TECHNICAL INFORMATION

Headlight Condensation Resolution

No: 86/04/05/NAS
FGN LT417-01
Ref:
Issue: 1
Date: 23 June 2005

Discovery Series II (LT)

Figure 1

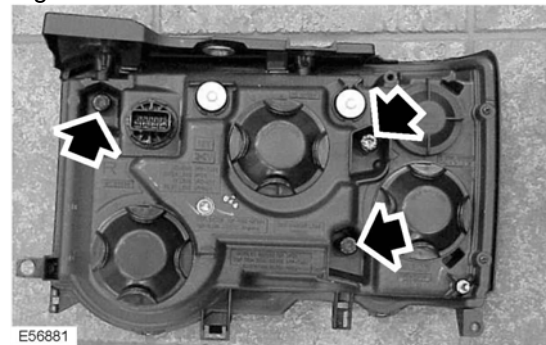
2. If following a period of normal operation the condensation has **dissipated** or is reduced to an acceptable level, perform the following:
 - Refer to GTR Workshop Manual section 86.40.49 and remove the headlamps.
 - Remove and discard vent tubes from headlamp. (Figure 1)
 - Install new vent tube set from kit XZX500010 to each headlamp.
 - Install modified headlamps.

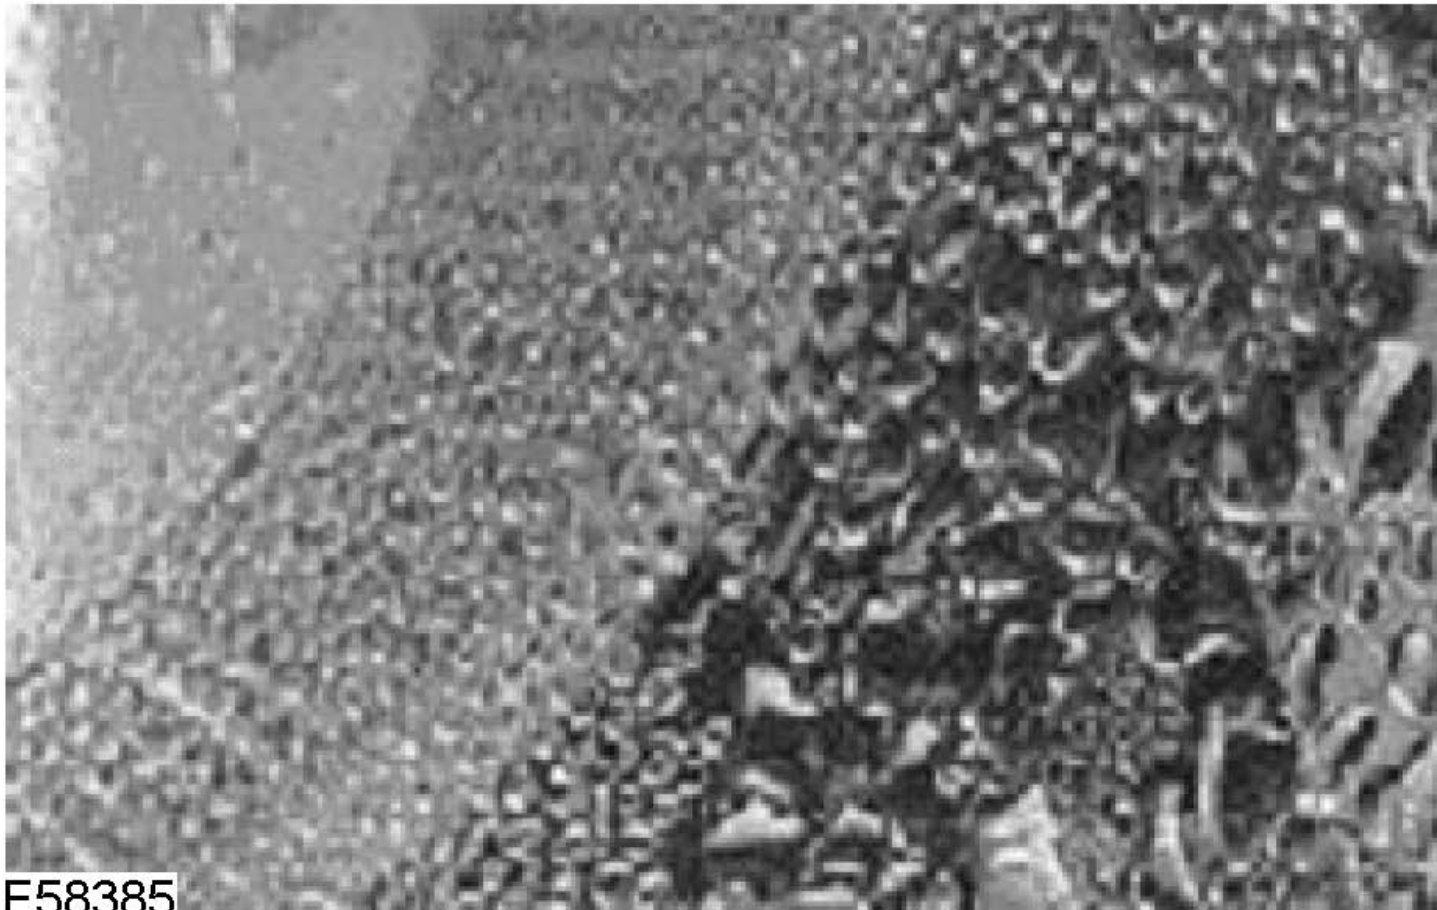
CAUTION: Replacement headlamp units taken from inventory with Part Number XBC001660 or XBC001670 require the installation of new headlamp vent tubes prior to installation onto the vehicle. Replacement headlamps PN XBC501460 or XBC501470 have the new vent tubes pre-installed.

3. If NEW replacement lamps XBC001660 or XBC001670 are to be installed, replace vent tubes with set XZX500010 to each headlamp.
4. If the following conditions apply, install new style or updated headlamps with latest style drain tubes:
 - Considerable water droplets remain on the inside of the headlamp glass after use.
 - Evidence exists of standing water within the headlamp unit.
